July 29, 2008

SUBJECT: Denison Mines (USA) Corp. (DUSA)
White Mesa Uranium Mill Cell 4A Operation
Record of Telephone Conversations and Request for Information

B
4,6 SECTION
SLIMES DRAIN HEADER
SCALE: 1" = 1'

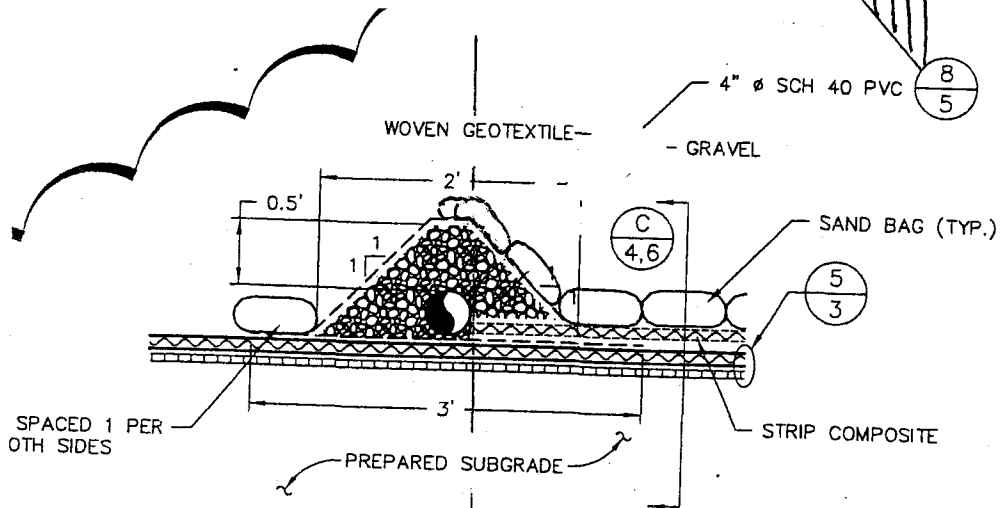
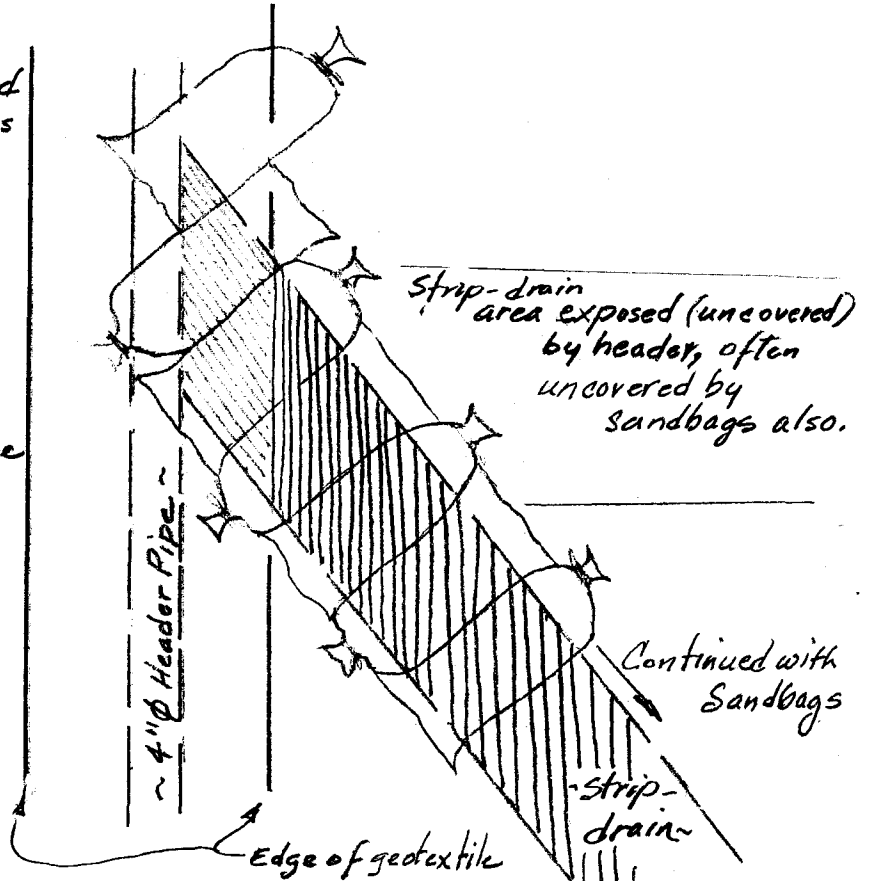
- a.) Sandbag Cover over the Strip-drains:
 - 1.) Sandbags which expose the strip-drain need to be adjusted to cover the same at all locations.
 - 2.) The exposed strip-drains at their junctions with the slimes drain header need to be properly covered with sandbags.
 - 3.) Sandbags need to be extended onto the slimes drain header windrow to cover and be in alignment above the slimes drain sections that are installed within the slimes drain header envelope of geotextile and gravel drain rock. See attached DRC sketch dated July 25, 2008.

Strip-drain
Area currently to be covered
by sandbags for filter as
req'd by specs.

strip-drain area
to be covered by sand-
bags and header envelope

Photo 2. Connection of fabrics between sandbag ballast, slimes drain backbone. Note rock exposed, but not on the liner.

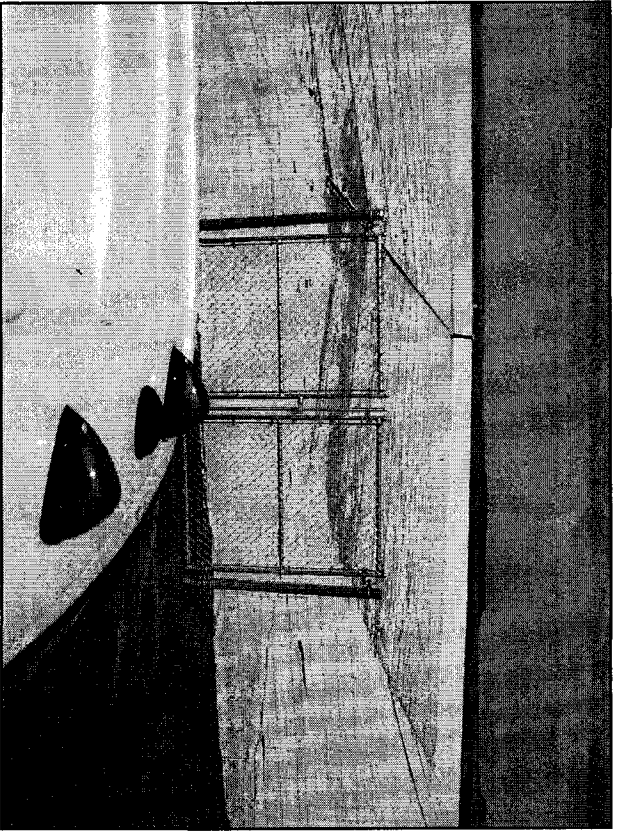
- c.) Drainage Rock for the Slimes Drain Header (Spine or Central Collection Pipe):
 - 1.) Drainage rock outside the geotextile envelope and on the cell liner needs to be removed.
 - 2.) In numerous locations, drainage rock in the header is exposed, yet cupped in the geo-fabrics of the slimes drain header (per attached photographs). This configuration does not conform to the original design drawings. A new aspect on this problem, not discussed with you on July 28, is that these openings to the drain rock will allow fines to flow into the slimes drain header, and plug or reduce the permeability of the slimes drain. Please change this configuration to conform to the original design, or propose an approvable remedy to eliminate the drain rock exposure to the tailings.
